UPDATED: URGENT Field Safety Notice

Trilogy Evo, Trilogy Evo O2, Trilogy EV300
Flow Sensor Nebulized Aerosol Deposition

21-NOV-2024

Reference: Flow Sensor Nebulized Aerosol Deposition
Trilogy Evo, Trilogy Evo O2, and Trilogy EV300
2024-CC-SRC-013

Figure 1: Acceptable In-Line Nebulizer Placement

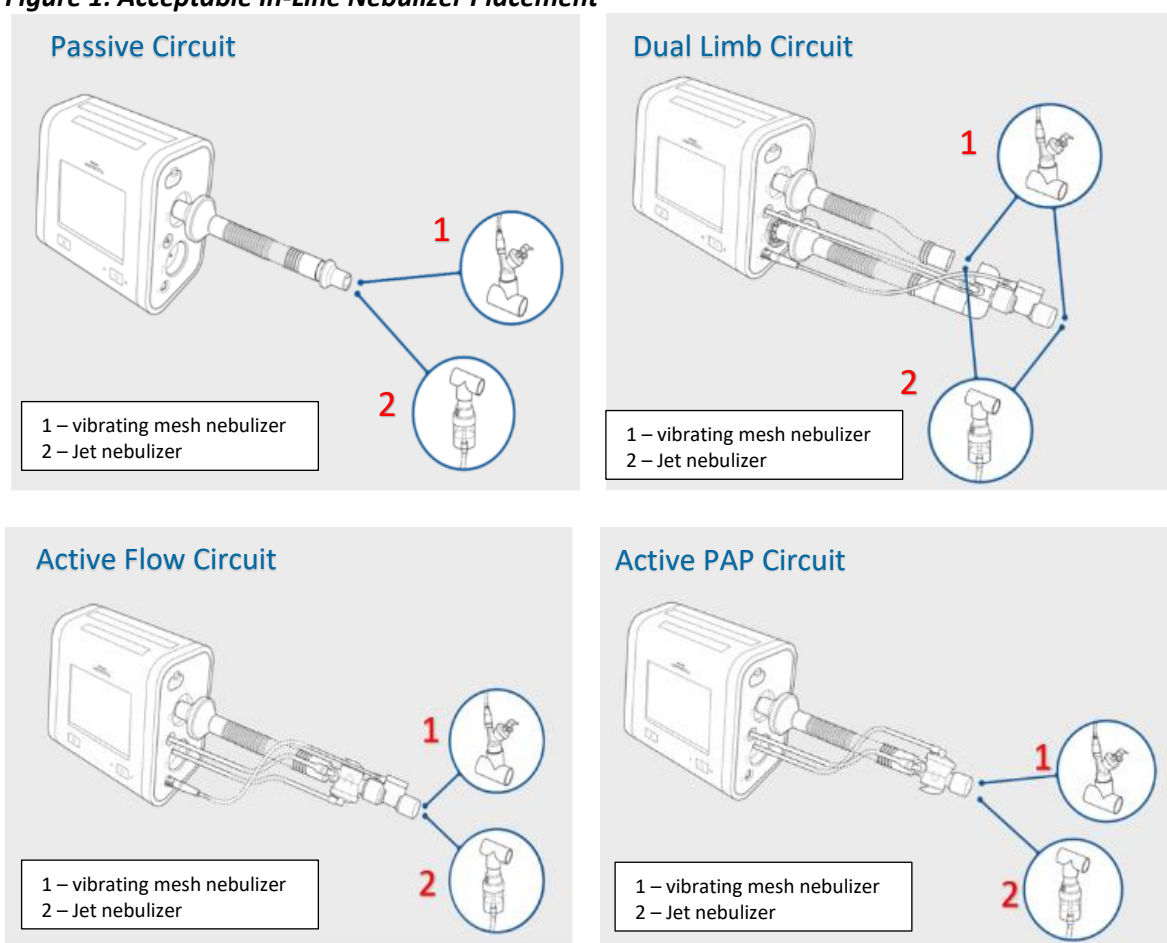
- If using in-line nebulizer treatments:
 - The circuit must be configured as pictured in the images in **Figure 1** below.
 - For prescriptions needing tidal volumes greater than 700 mL with a passive circuit, transition patient to alternate circuit (Active PAP, Active Flow, or Dual Limb).

- When tidal volumes greater than 700 mL are used with a passive circuit, nebulized aerosol deposition can occur even if the nebulizer is placed as pictured.

Appropriate Circuit Configurations for Use With In-Line Nebulizers

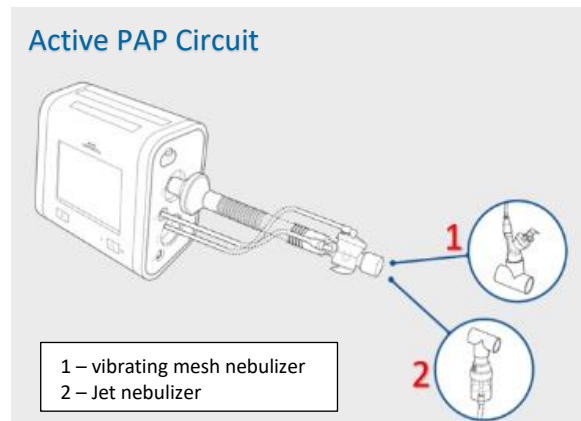
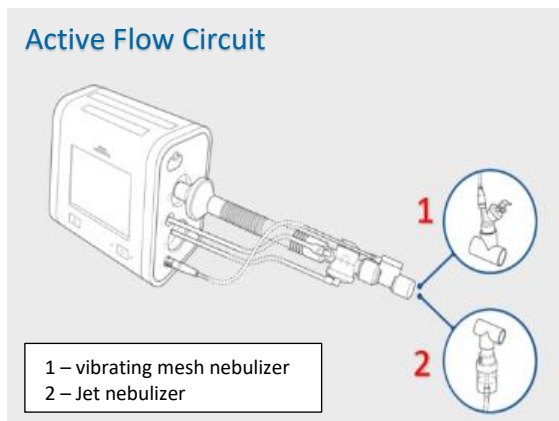
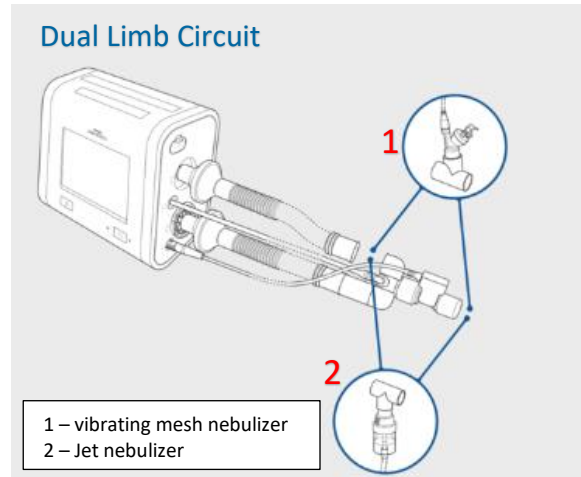
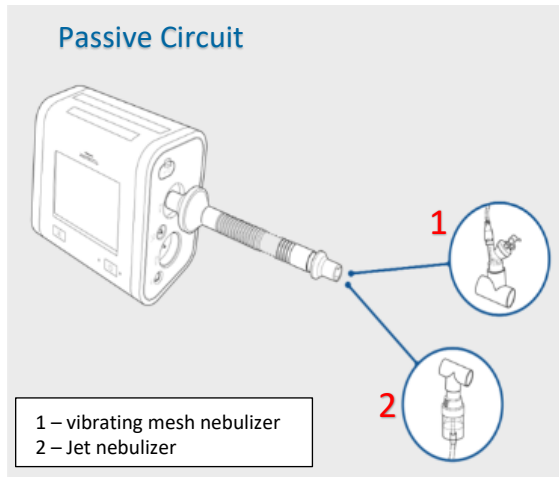
If using in-line nebulizer treatments, ensure the circuit is configured as shown in the images below.

Note: For prescriptions needing tidal volumes greater than 700 mL with a passive circuit, transition patient to alternate circuit (Active PAP, Active Flow, or Dual Limb).

- When tidal volumes greater than 700 mL are used with a passive circuit, nebulized aerosol deposition can occur even if the nebulizer is placed as pictured.
